Safety Evaluation Report

related to the operation of
**Shoreham Nuclear Power Station,
Unit No. 1**

Docket No. 50-322

Supplement 7 (SSER 7) to the Safety Evaluation Report on Long Island Lighting Company's application for a license to operate the Shoreham Nuclear Power Station, Unit 1, located in Suffolk County, New York, has been prepared by the Office of Nuclear Reactor Regulation of the U.S. Nuclear Regulatory Commission. This supplement addresses several items that have been reviewed by the staff since the previous supplement was issued.

Figure 3.2.1 Problem-solving human error probability vs time - screening values.

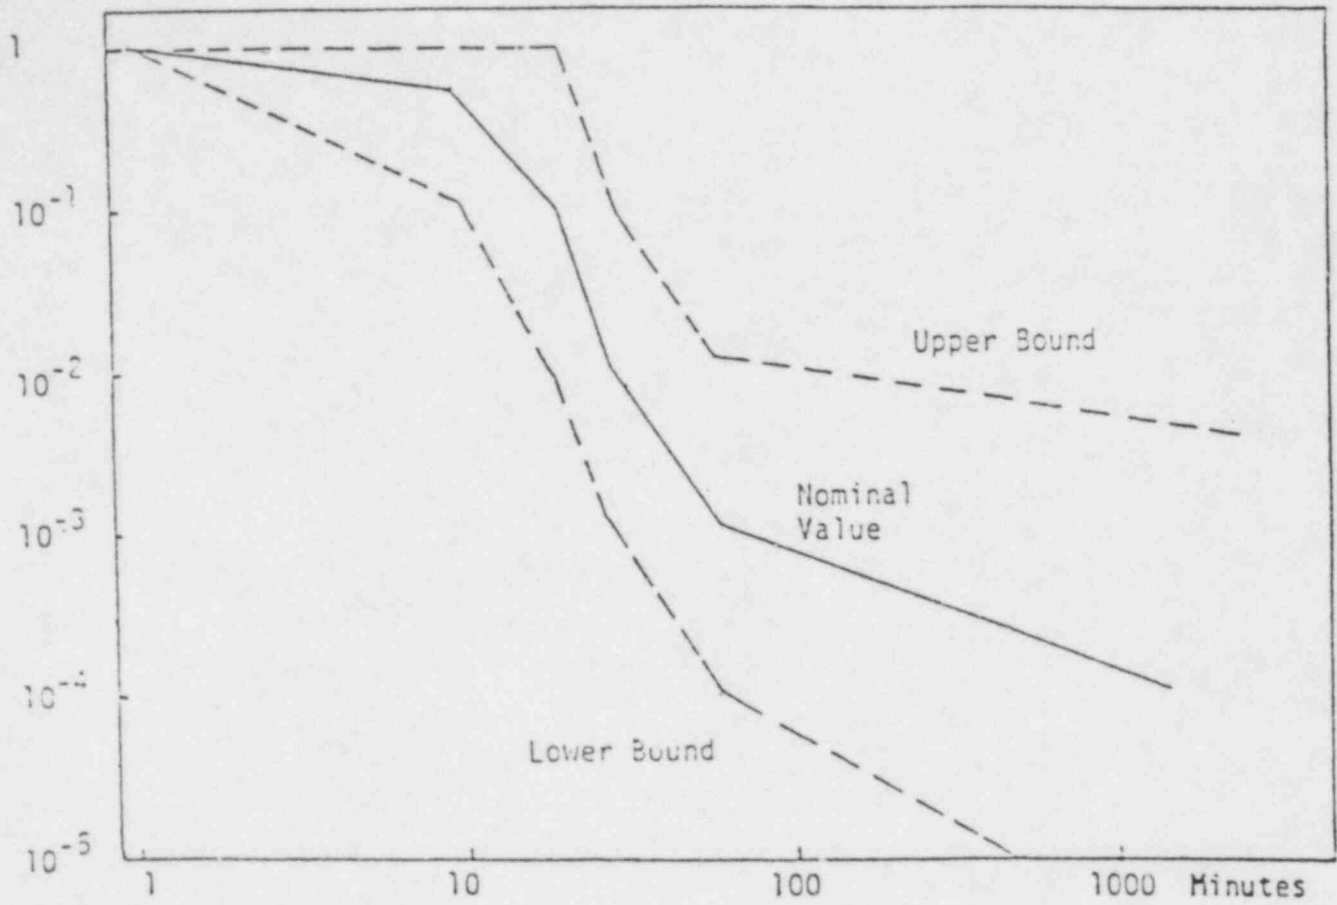
The HEP values used by SNPS are identical to the nominal HEP values provided in the Probabilistic Risk Analysis Procedure Guide⁽⁷⁾ (see Figure 3.2.1 and Table 3.2.3). BNL feels that the HEP could be higher than the nominal HEP values because the flooding alarm related procedures fail to provide specific guidelines to identify and to isolate the flood source (see Section 3.2.1).

Figure 3.3.1 Phase I of Internal Flood Functional Event Tree

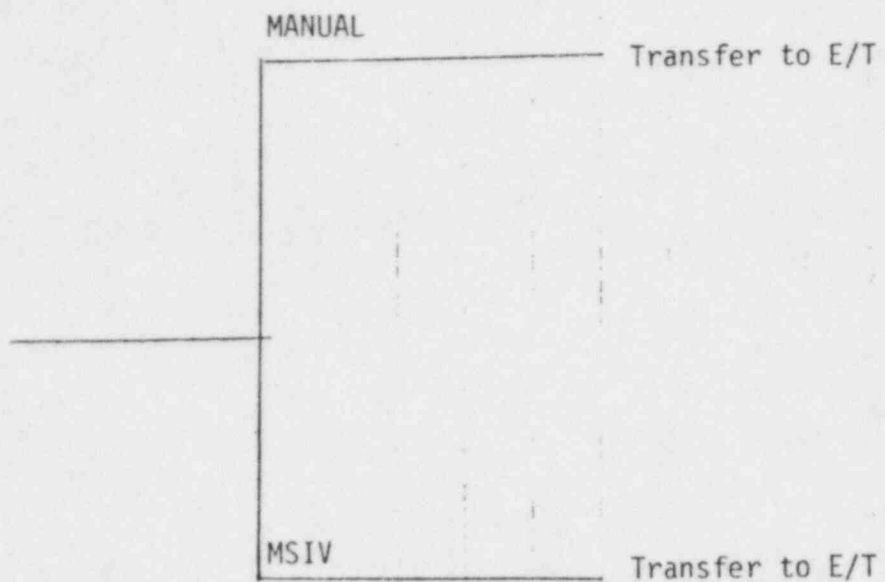
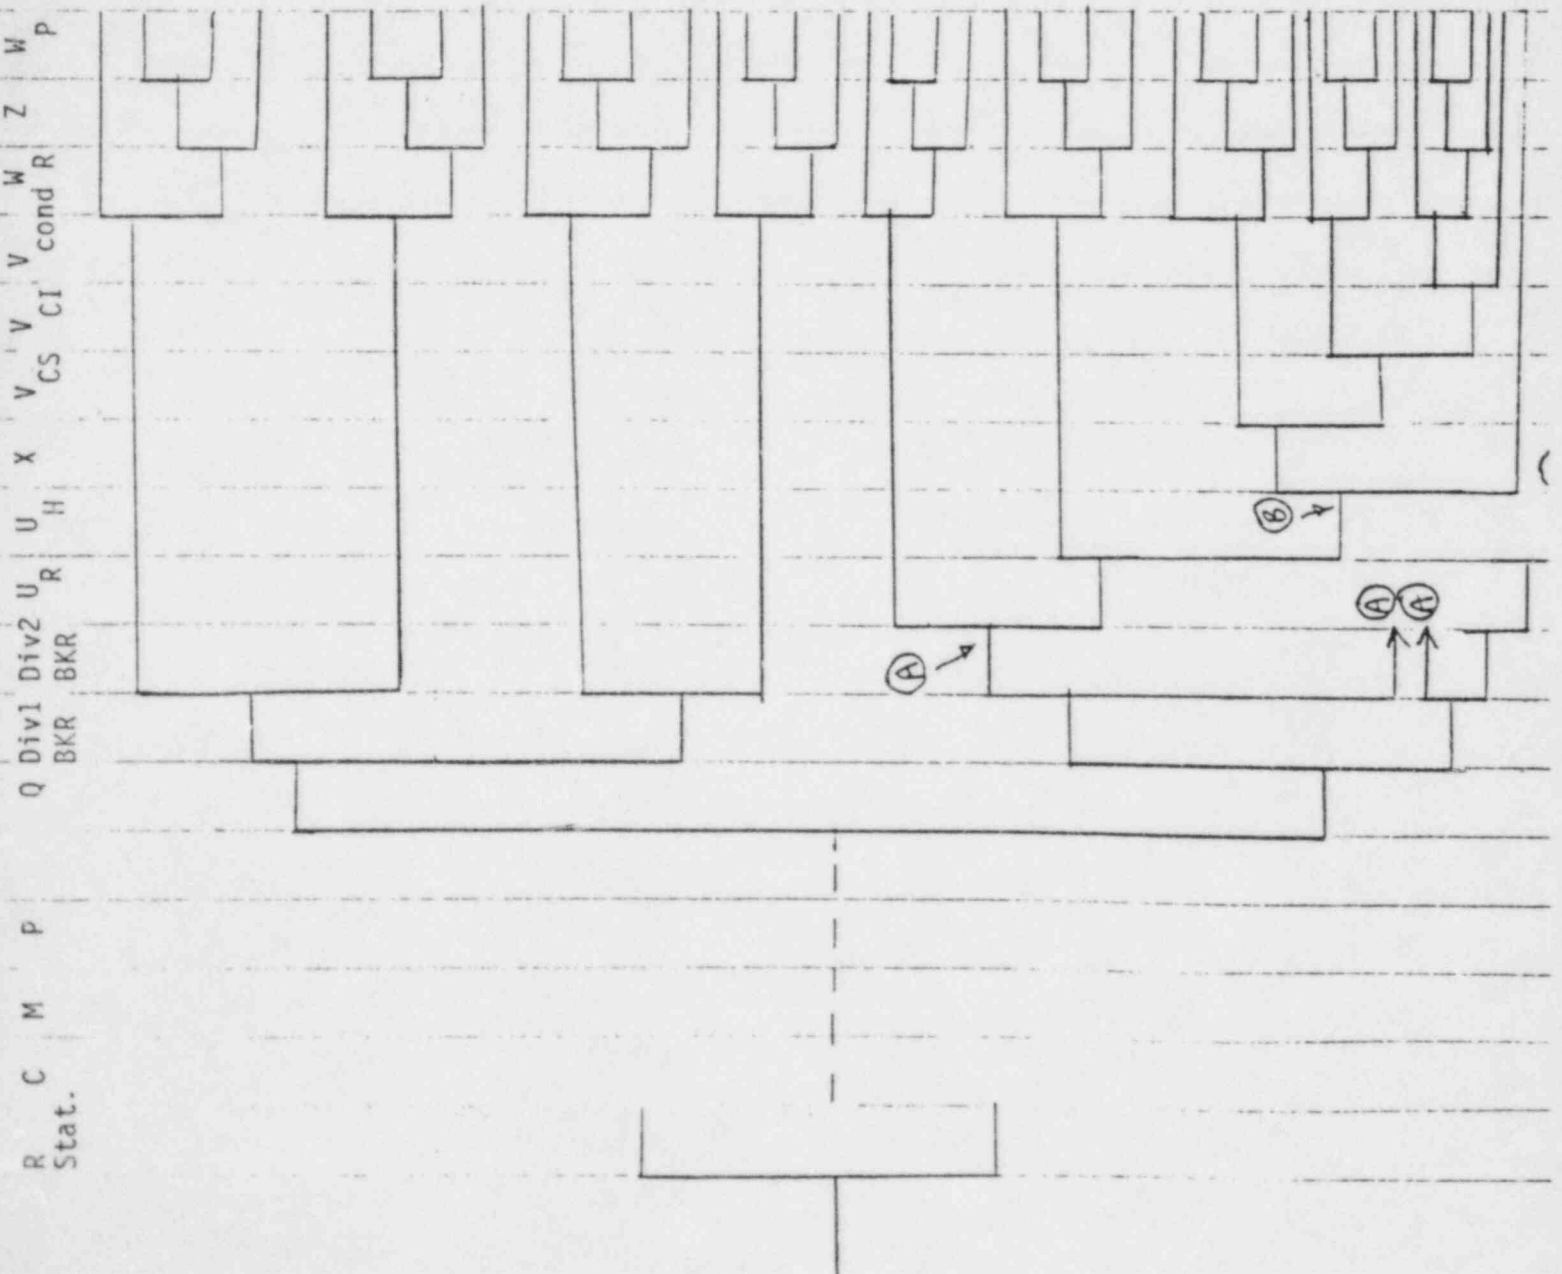
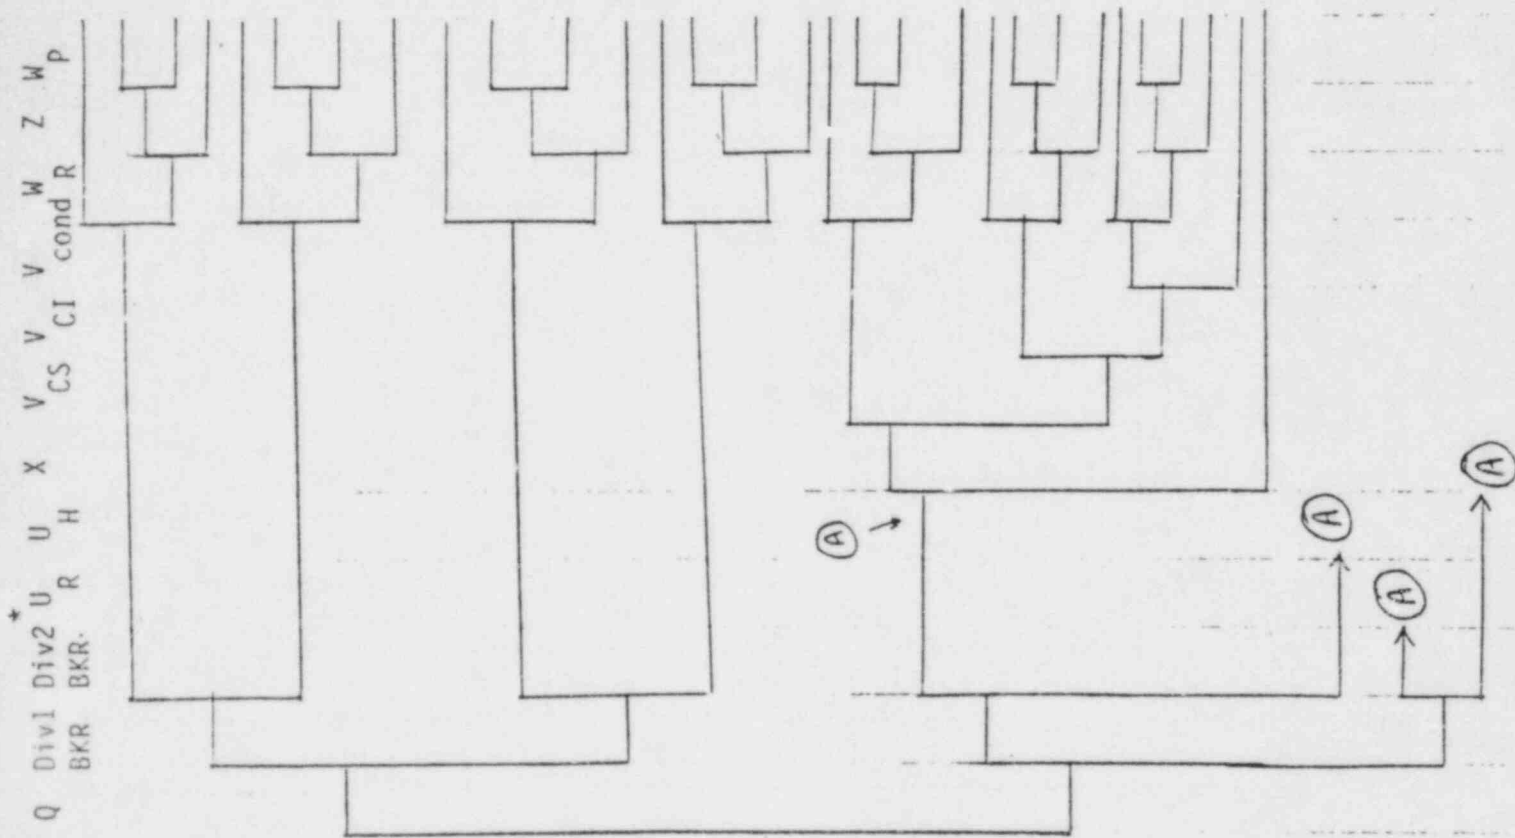
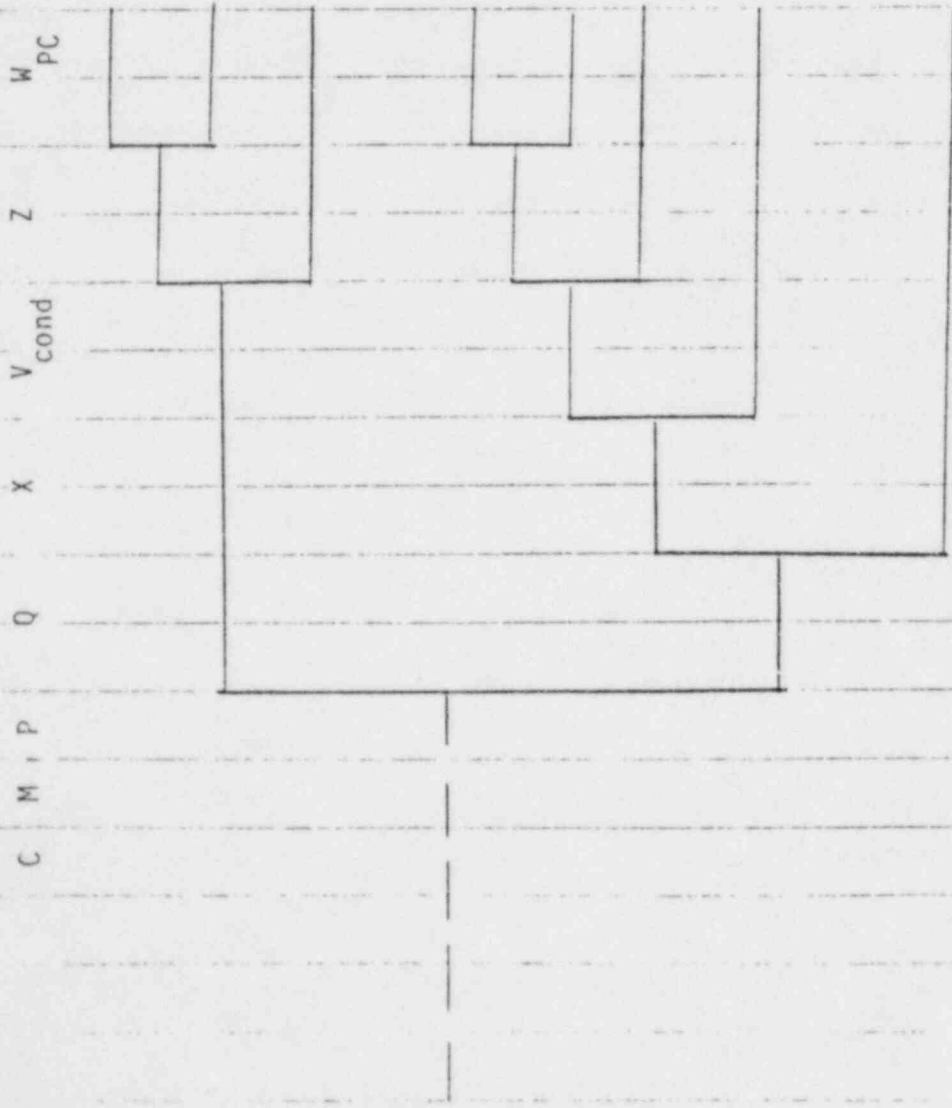
The event trees of these four phases are presented in Figures 3.3.1 through 3.3.4. Given that the flood is terminated in Phase I, BNL assumed that the reactor has a high probability (0.9) that it will be manually shutdown. Ten percent of the time, it may result in a MSIV closure event. These two branches of the Phase I event trees are transferred to the respective internal event tree, Figure 3.3.1.

Figure 3.3.2 depicts the Phase II functional event tree which considers the various accident mitigation systems. Moreover, owing to the fact that a number of the 480V pumps will be flooded, the possibility of a breaker failure to isolate the fault is also evaluated. It is assumed that the breaker failure to open probability is 1×10^{-3} and there are a total of five pumps in Division I and two pumps in Division II that will be short circuited. A probability of 0.5 is also assumed that failure of a load center in a division would lead to failure of other equipment connected to that division. In the event of a MSIV closure, the feedwater system is considered to be unavailable. The probability that the reactor will be manually shutdown is also assumed to be 0.9 for the maintenance induced flood events.

Figure 3.3.3 illustrates the functional event tree used to describe the Phase III events. The major difference between this event tree and the Phase

The Phase IV event tree is presented in Figure 3.3.4. This tree is drastically different from the other ones in that it only considers the feedwater system, the depressurization function and the PCS. All the other systems are disabled due to flooding. The likelihood that the reactor will be manually shutdown is the same as in Phase III for maintenance-induced floods.
